**CUMNOR PARISH COUNCIL**  
**Minutes of the Meeting of the Planning Committee**  
**held on Monday 19 February 2024 at 7.30pm**  
**in Fogwell Road Pavilion, Fogwell Road, Dean Court.**

**16/24 Submitted planning application.**

Refused 2022 proposal ( <a href="#">P22/V2863/FUL</a> - extract from site and block plan)	Refused 2023 proposal ( <a href="#">P23/V1280/FUL</a> extract from site and block plan)	Current application <a href="#">P24/V0007/FUL</a>

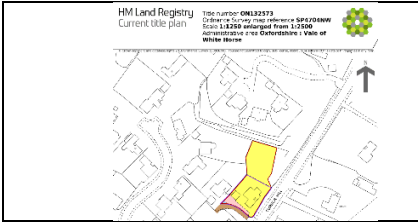
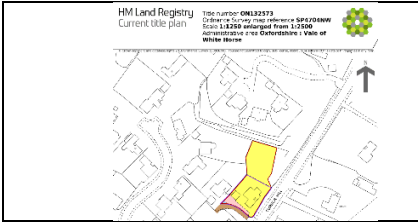
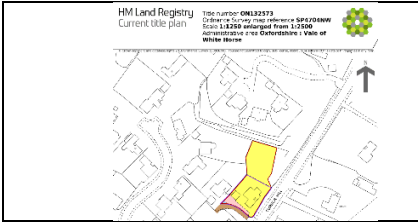
- Placing the 2022, 2023 and 2024 applications side by side (see figure above) shows the similarity of the proposals in mass, scale and impact on building/plot ratio. The table below shows comparable dimensions taken from the applications.

- The Design and Access statement (para 7.2) asserts that the development would take up 13.8% of the plot. Given that the plot size is 1027 sq m, the proposed house having a footprint of at least 167 sq metres and with 110 sq m of parking/hard standing the development would occupy 27% of the plot.
- The proposed parking provision at the front of the building (Cumnor Hill side) as shown in the 'Transport Statement March 2023' document is the same as that in the refused application [P23/V1280/FUL](#) where the nature of the provision:

Proposed outbuilding

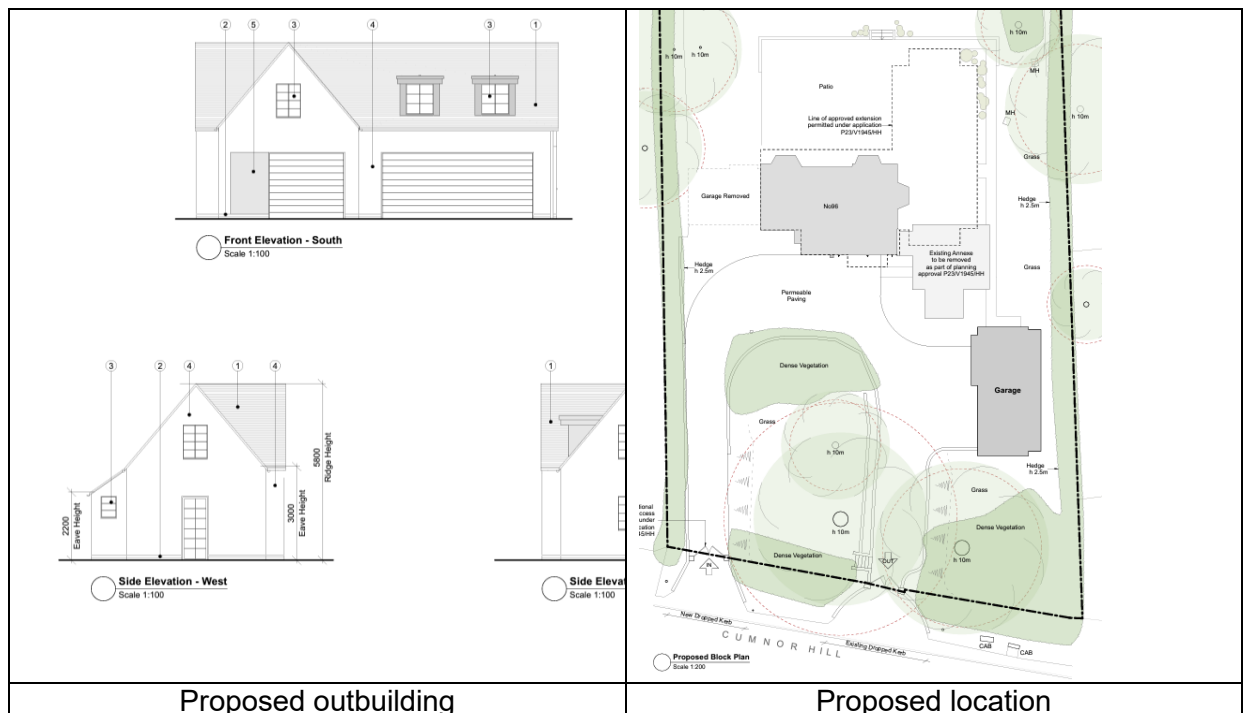
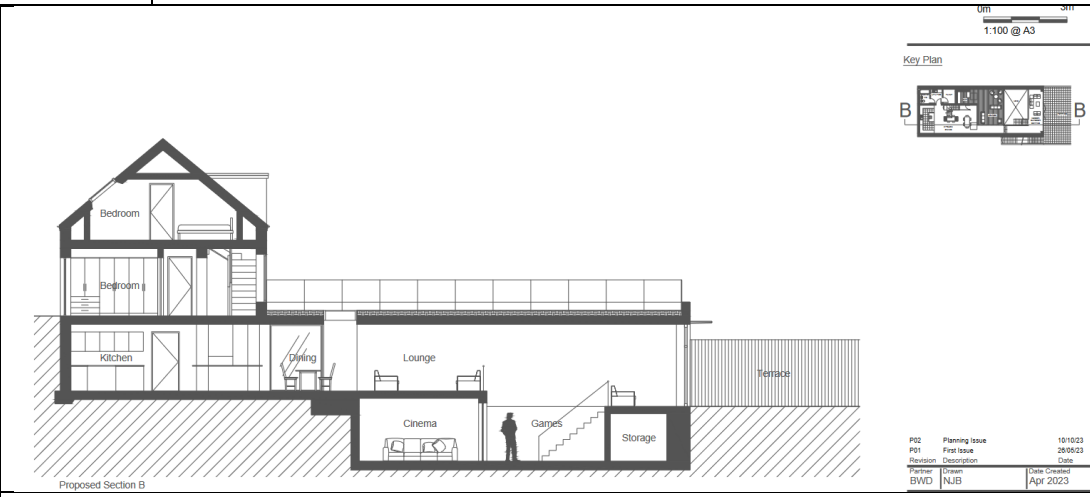
- Council objects to the scale and position of the proposed outbuilding.

- The 'street side' 6.25m wide x 6.25m high end gable wall does not conform with Neighbourhood Plan Policy DBC1's principle of 'active frontages' (para 77)
- The size and position of the outbuilding does not conform with Policy DBC 3, as it intrudes in the streetscene.
- Notwithstanding the above, if VWHDC choose to grant planning permission Council would request that a condition be applied stating that the outbuilding may not be separately occupied, let or sold with respect to 96 Cumnor Hill.

Site location	Proposed sub division

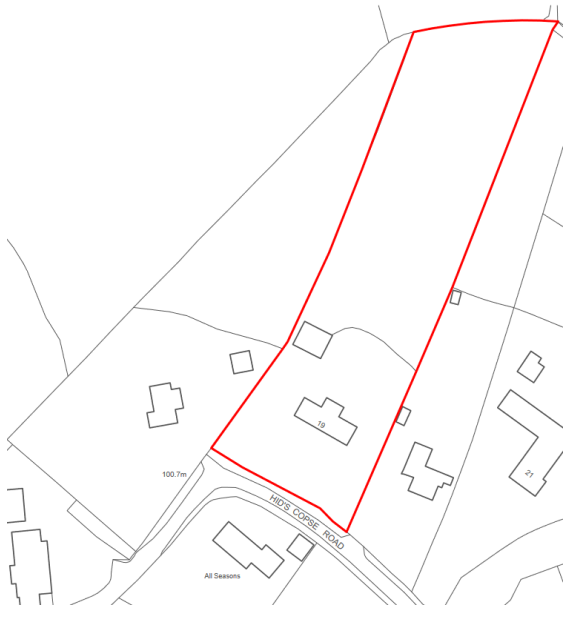
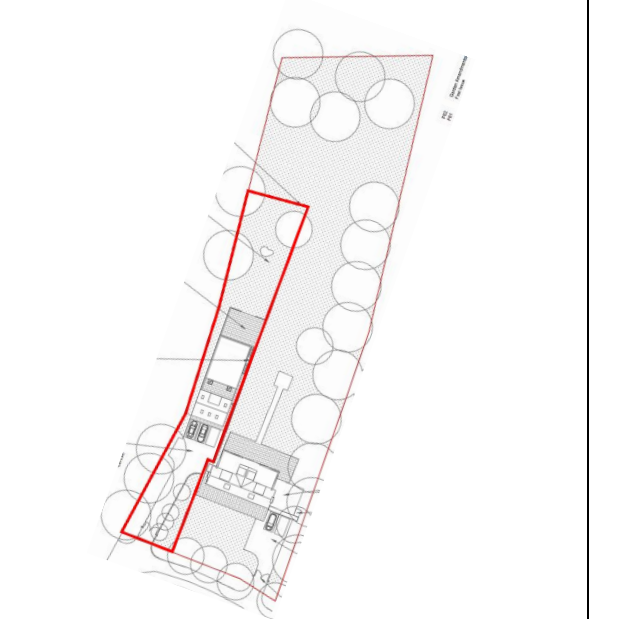
North east elevation of existing structure (not south east as labelled in design and access statement)	South west elevation of existing structure as seen from Hids Copse Road
<ul style="list-style-type: none"> <li>The VWHDC pre-app concludes (emphasis added): <p><i>The proposed development is likely to be supportable in principle, in accordance with Green Belt policy and unharmed to neighbours and highway safety. More details are necessary to determine whether there would be harm to ancient woodland and important trees. Notwithstanding this, at this stage, <b>the subdivision of the plot is considered to be out of keeping with local character and contrary to policies of the neighbourhood plan which seek to protect the low-density nature of the area.</b></i></p> <p><i>As previously stated, a site visit would be necessary to conclusively determine whether the subdivision would be harmful given its potentially limited visibility. Should harm be identified this would need to be weighed against the benefits of the proposals.</i></p> </li> </ul>
